Model	Sorter Stapler for F40	Volt/Hz	Date of Modification	Serial Number
Modified Article	Parts Catalog			
Reason for Modification	Parts catalog correction

Model	Sorter Stapler for F40	Volt/Hz	Date of Modification	Serial Number
Modified Article	Vertical Transport Roller/Spacer - 4.1 x 6 x 3.2			
Reason for Modification	Parts standardization

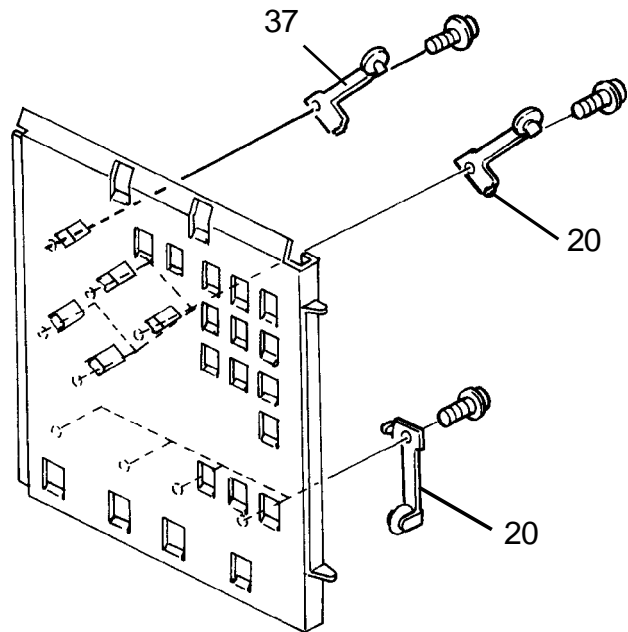
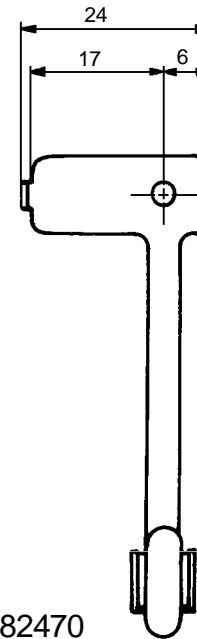
Please correct your parts catalog as follows:

P/N	Description	Q'ty	Index No.	Page
Incorrect	A4982455	Diagonal Driven Roller	9	20	9
Correct	A4982455	Diagonal Driven Roller	8	20	9
	A4982470	Diagonal Driven Roller - Front	1	* 37	9

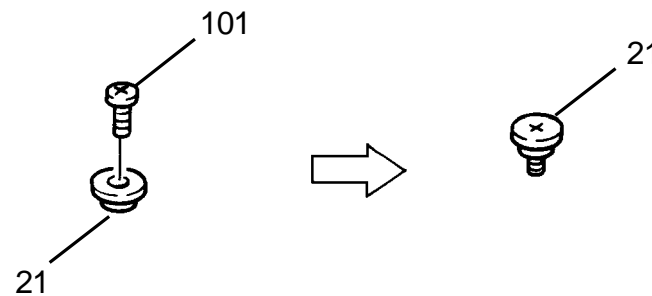
To standardize parts with the other model, the vertical transport roller and the spacer - 4.1 x 6 x 3.2 have been changed. The interchangeability for each is O/O.

Old P/N	New P/N	Description	Q'ty	Index No.	Page
A4982435	A3662435	Vertical Transport Roller	3 → 3	12	7
			1 → 1	11	9
A4983113		Spacer - 4.1 x 6 x 3.2	6 → 0	21	11
03140060W		Philips Pan Head Screw - M4 x 6	6 → 0	101	11
	67543278	Stepped Screw	0 → 6	21	11
50540536	AG070004	Magnet Catch Ass'y	1 → 1	26	11

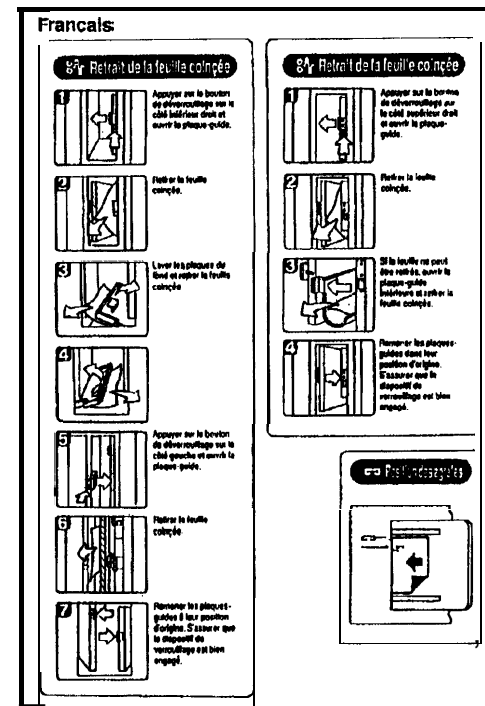
As per field request, the decal sheets have been registered:

P/N	Description	Q'ty	Index No.	Page
A4981860	Decal Sheet - German	1	9	39
A4981861	Decal Sheet - French	1	9	39
A4981862	Decal Sheet - Italian	1	9	39
A4981863	Decal Sheet - Spanish	1	9	39

DETAILS OF MODIFIACATION

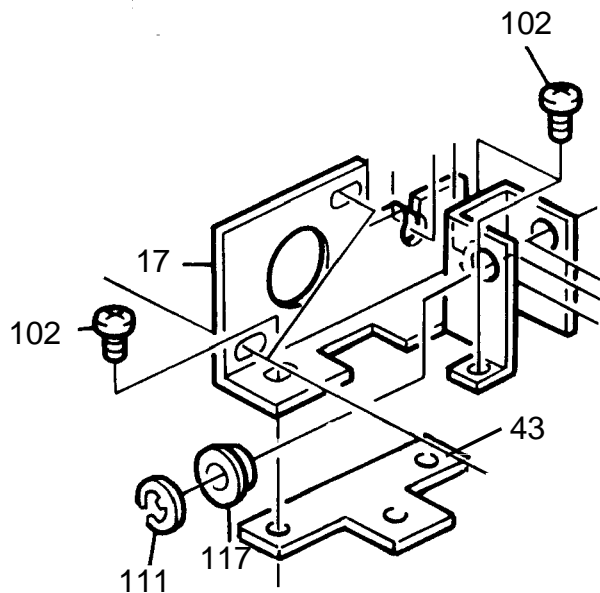
Sometime the stapler unit stops as it is moving.

The tension of the timing belt which drives the stapler unit is poor, the timing belt sometime runs on the cog of the pulley.

To tighten the tension of the timing belt, a spacer has been added under the motor bracket.

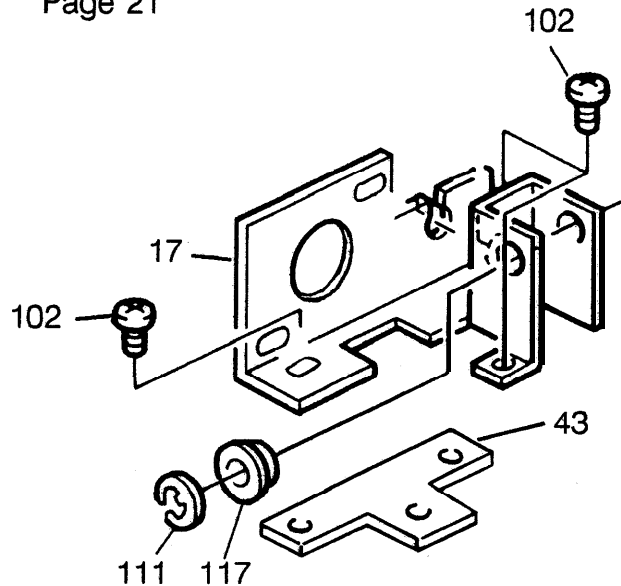
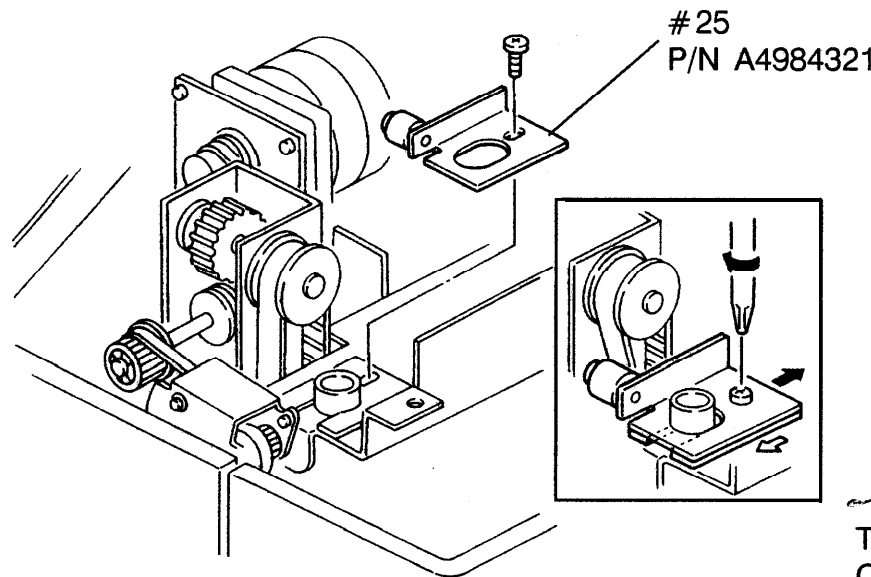
To improve the stapler unit movement, the tightener has been added instead of the motor bracket spacer (index 43) which was added by MB No. 2.

Old P/N	New P/N	Description	Q'ty	Interchangeability	Index No.	Page
A4984311		Motor Bracket Spacer	1 → 0	X/	43	19 (21)
	A4984321	Tightener	0 → 1	/O	* 25	17 (19)

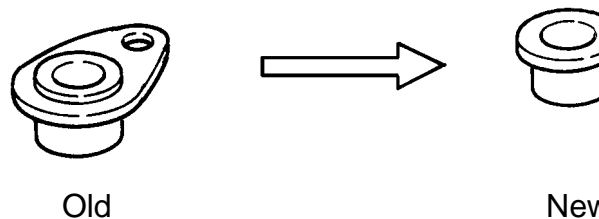
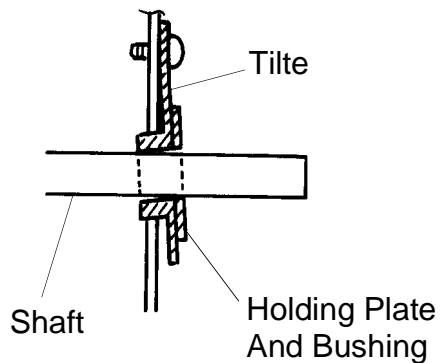
The Holding Plate And Bushing is tilted when tightened by a screw. This generates the noise while the shafts are rotating. To prevent this problem, the bushing has been changed to the ball bearing.

Old P/N	New P/N	Description	Q'ty	Interchangeability	Index No.	Page
A4581561		Holding Plate And Bushing - 6X12X4	5 → 5	X/O	2	23
		Ball Bearing			9	25
	08053145				119 * 113	23 25
